# 162 Queens Quay East

Detailed Design

Review Stage: Detailed Design

# May 2019 DRP- Consensus comments

## GROUND FLOOR PLANS

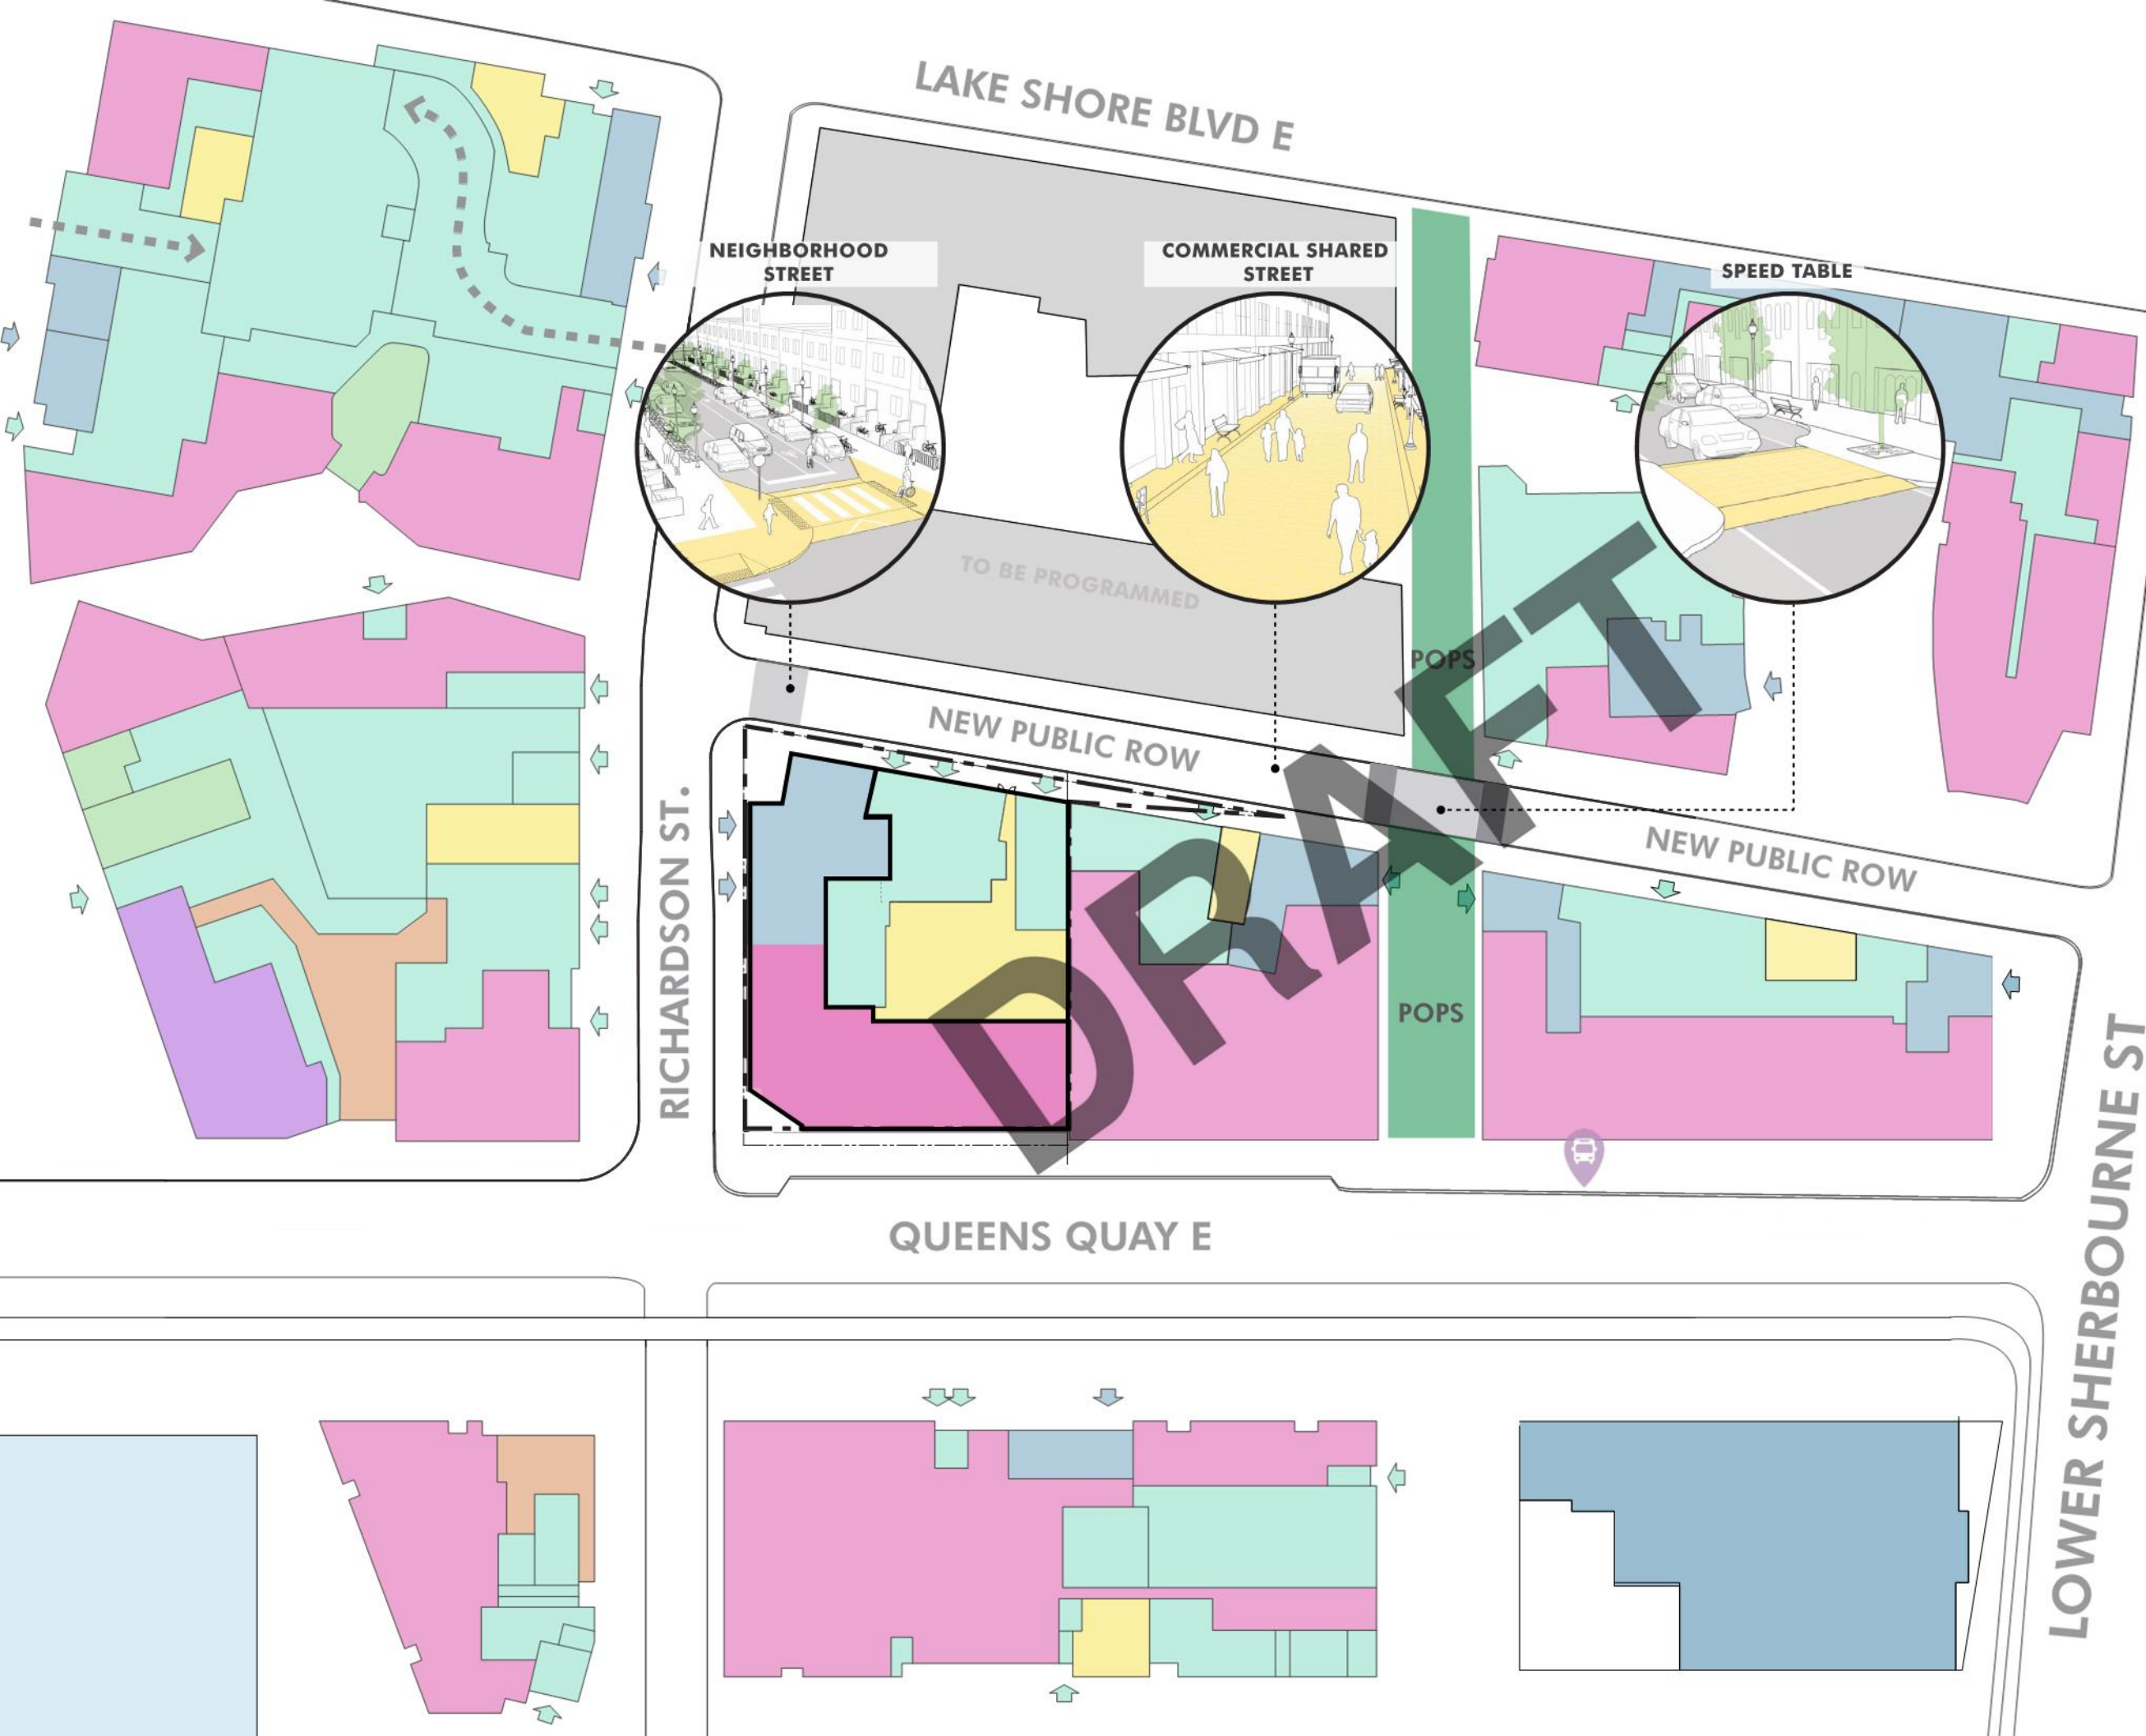
\*As per comment from July 24, 2019  
 - Show more context program including adjacent streets in all directions, buildings, and public realm

- Additional context shown. Opportunity to explore providing a different paver on the New Public ROW, and option to include a raised crosswalk between the POPS. These measures would define the New Street, assist with traffic calming and encourage a pedestrian friendly environment between blocks.

EXISTING MATERIAL PALETTE

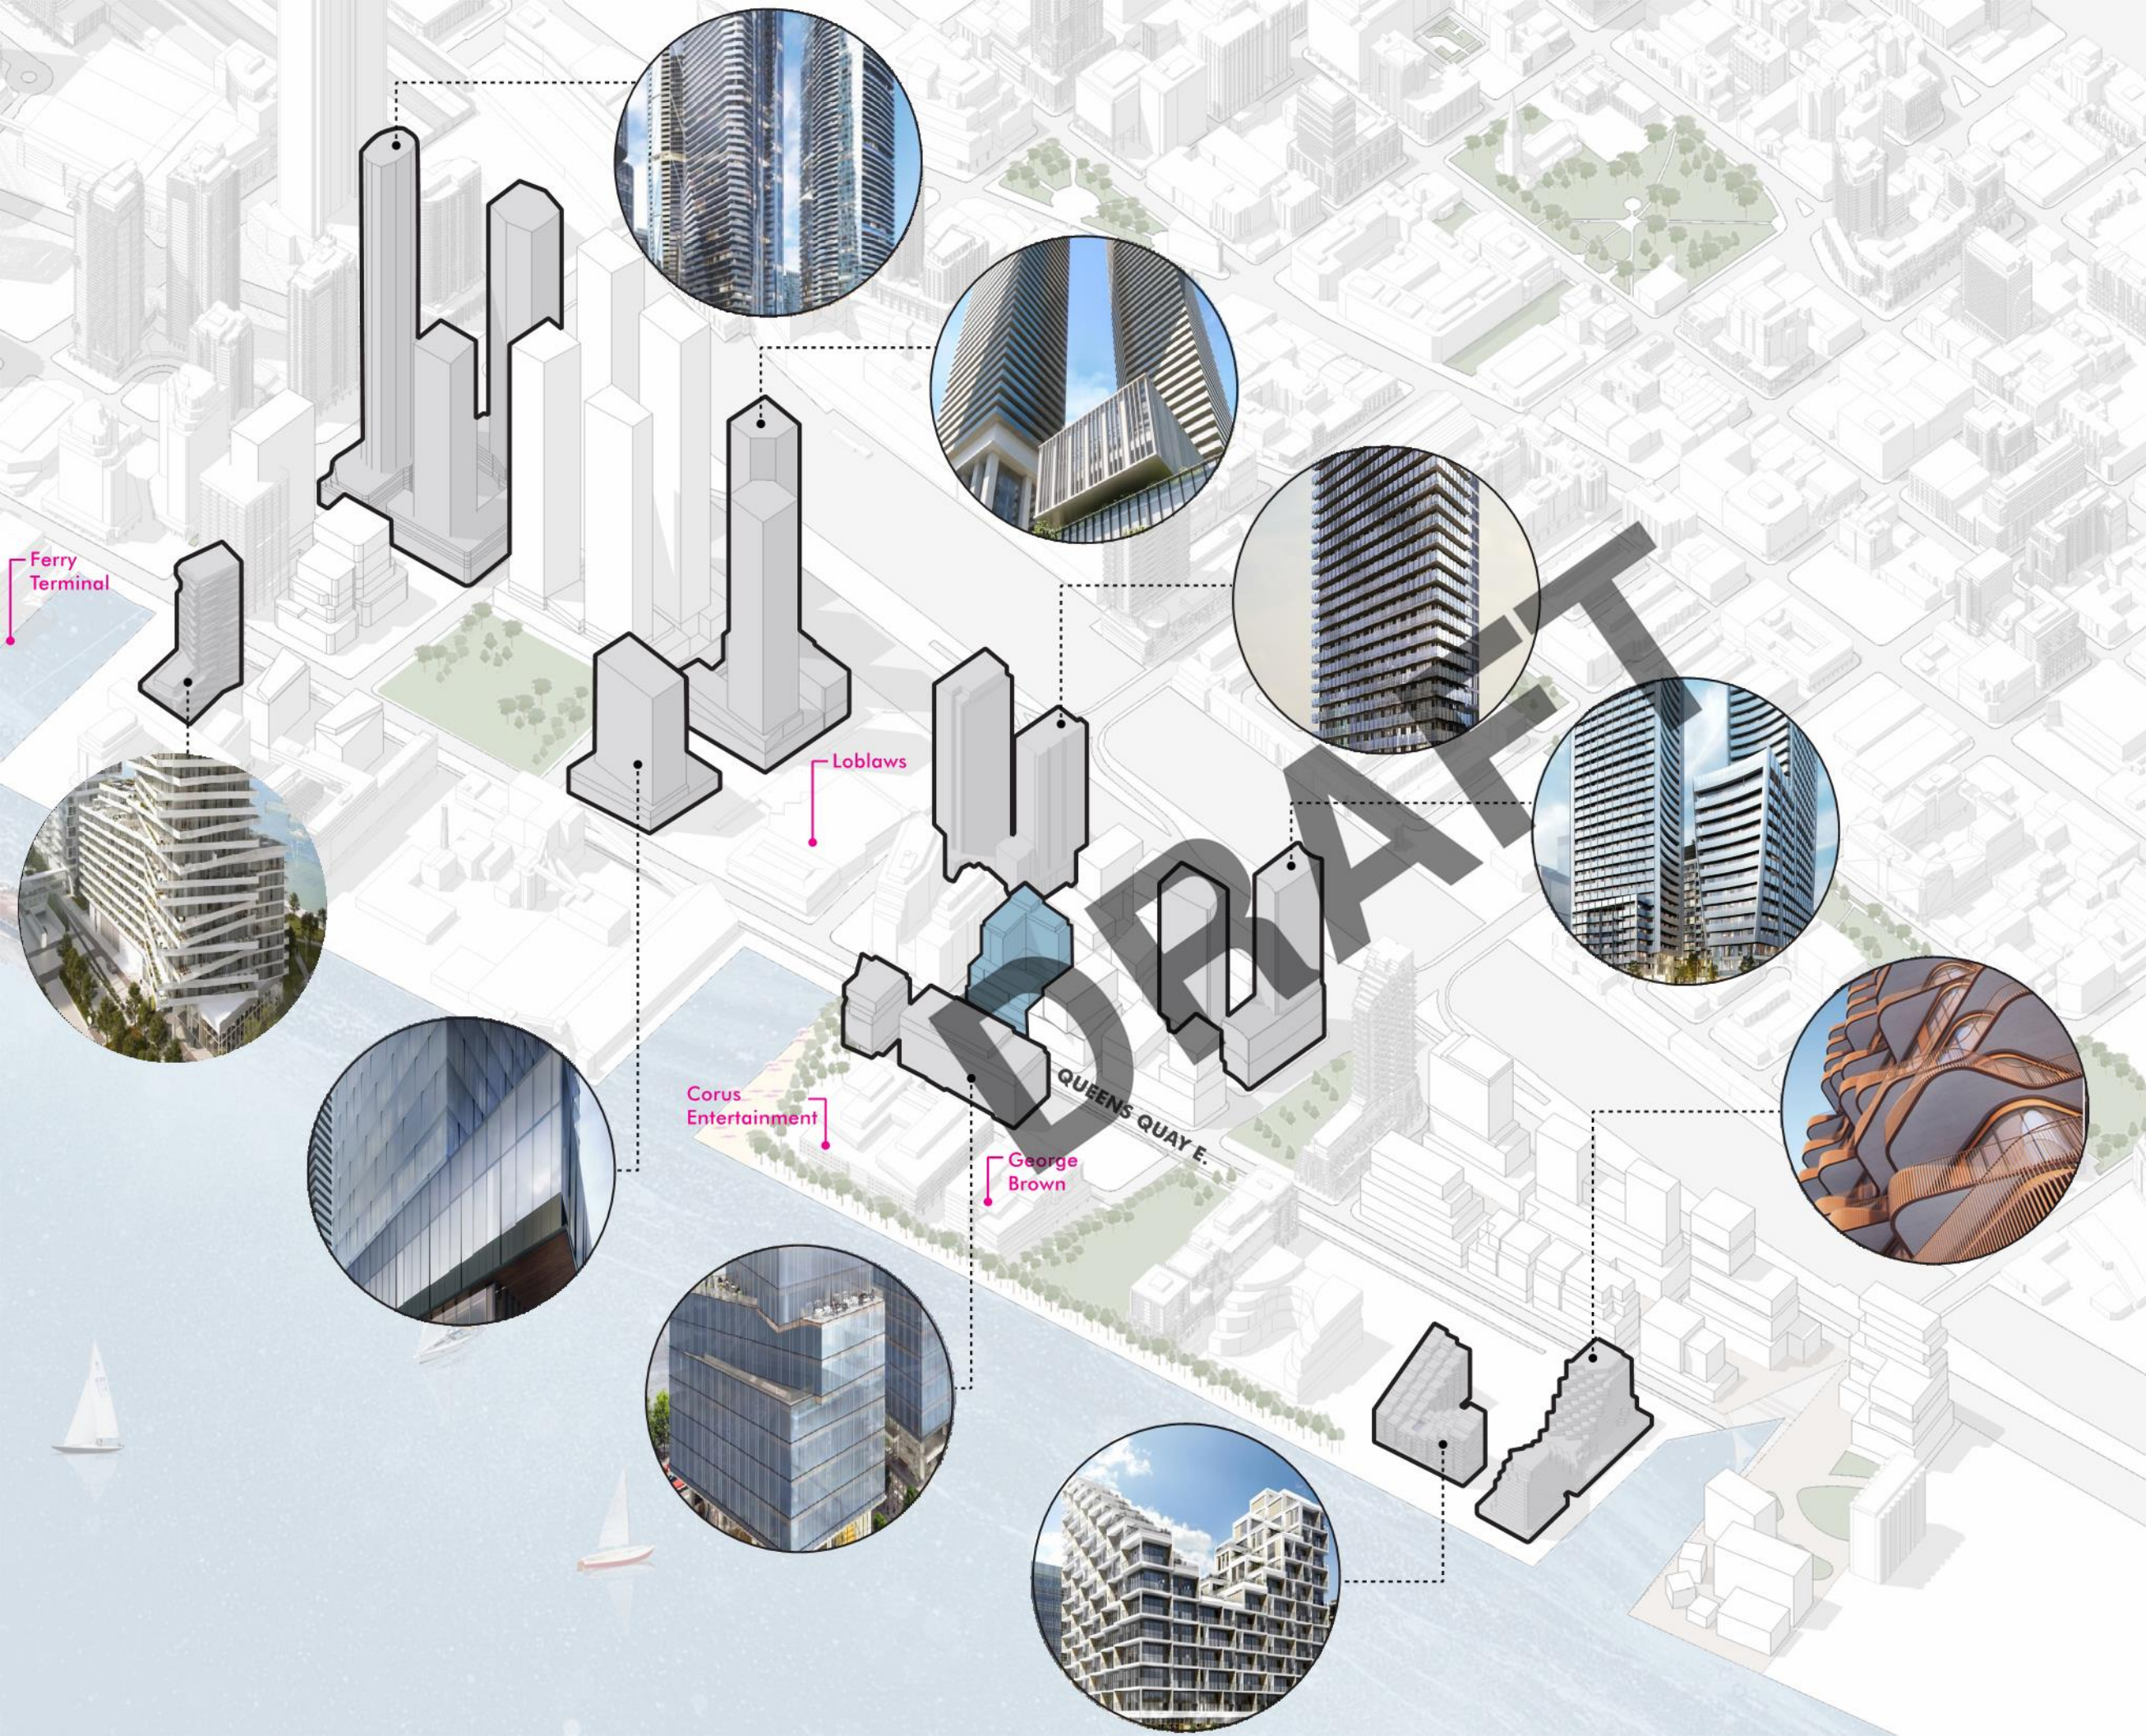
- Consider the integrity of the material and how it contributes to the identity of the neighbourhood

- Analyzed and understood the existing and future materials found throughout the neighbourhood. Proposed materials compliment the other developments in a similar language.

MATERIAL PRECEDENTS

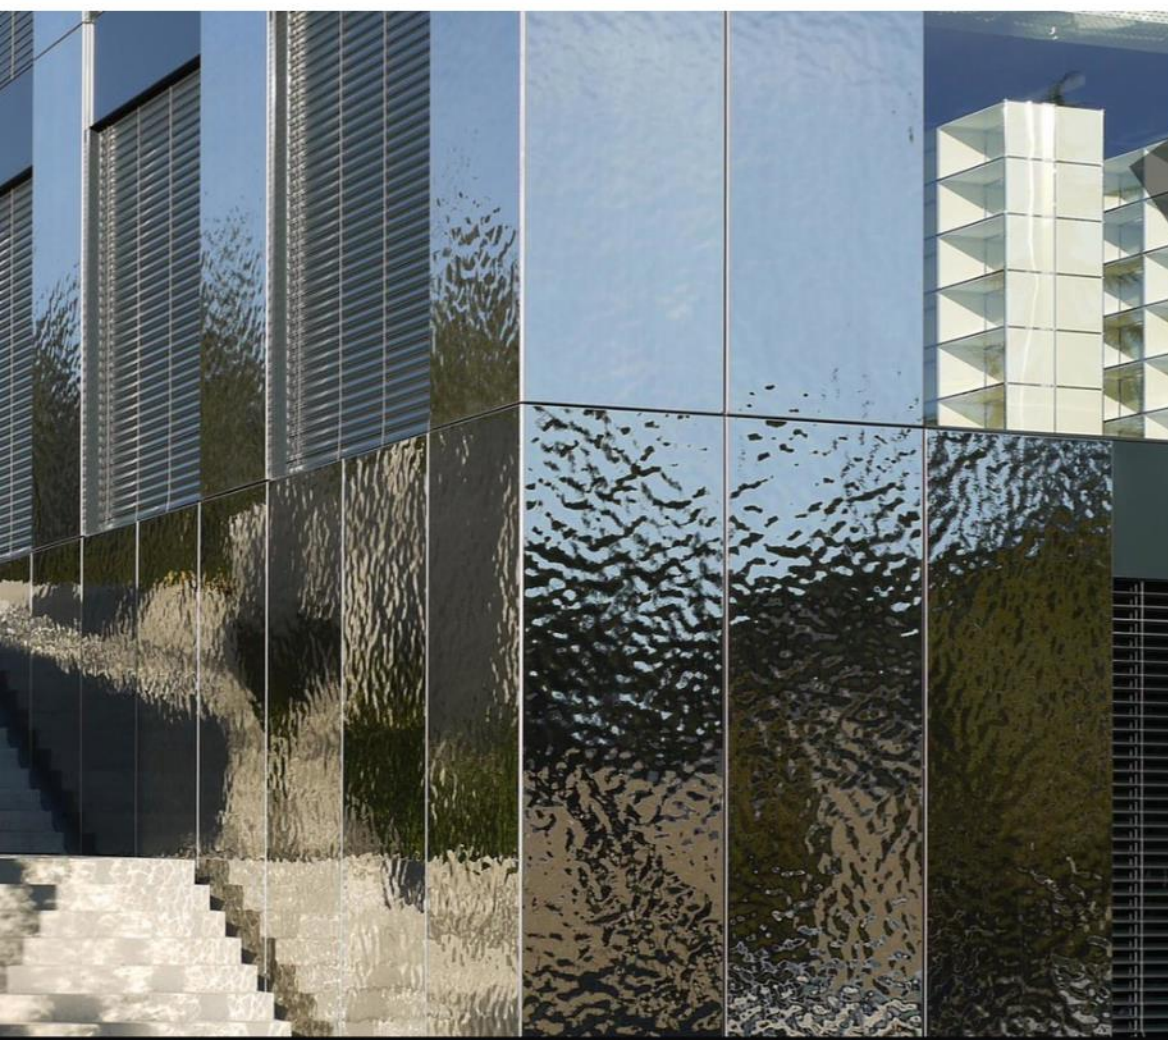
- Create subtle materiality changes. Consider tones of shimmer, silvers and grays.

- Introduced reflective panels to create the effect of movement along the elevation as the sun and clouds move around the building throughout the day.

RETAIL STREETSCAPE

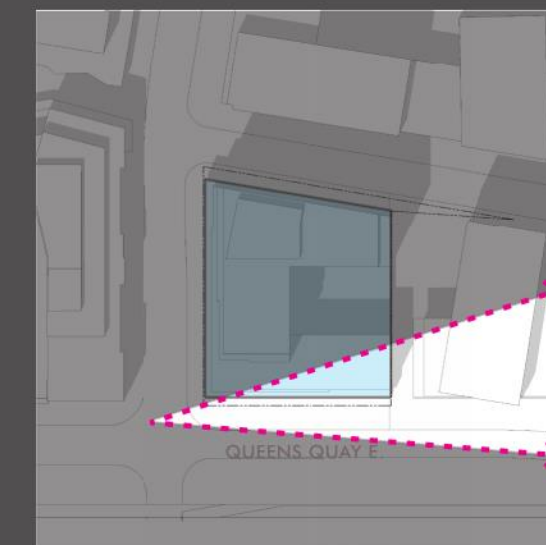
- Consider diversifying the materials on the Ground floor

- The Ground Floor mixes the panels used in the building with wooden panel details that bring a warmth to the streetscape and connects to the landscape

3RD FLOOR SKYLIGHTS

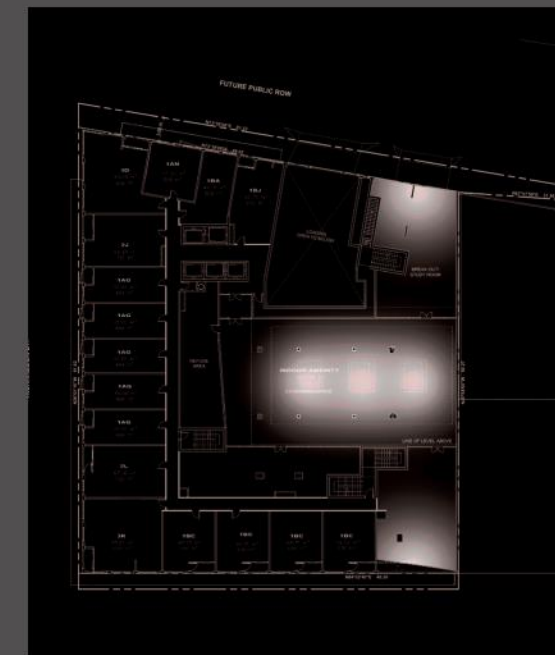
- Consider quality of light and maximize light in Amenity Area

- The proposed skylight takes advantage of the courtyard to allow light to flow into the proposed co-working area of the Amenity space.

\*Subject to review by structural and window manufacturer

3RD FLOOR SKYLIGHTS

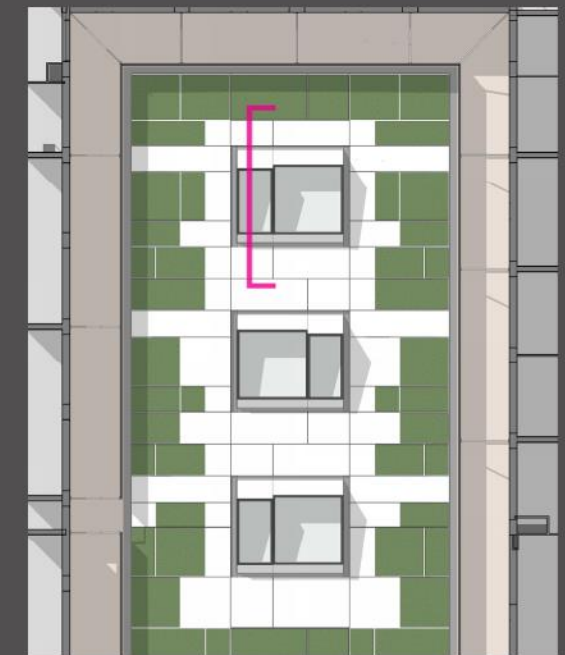
- Consider quality of light and maximize light in Amenity Area

- The proposed skylight takes advantage of the courtyard to allow light to flow into the proposed co-working area of the Amenity space.
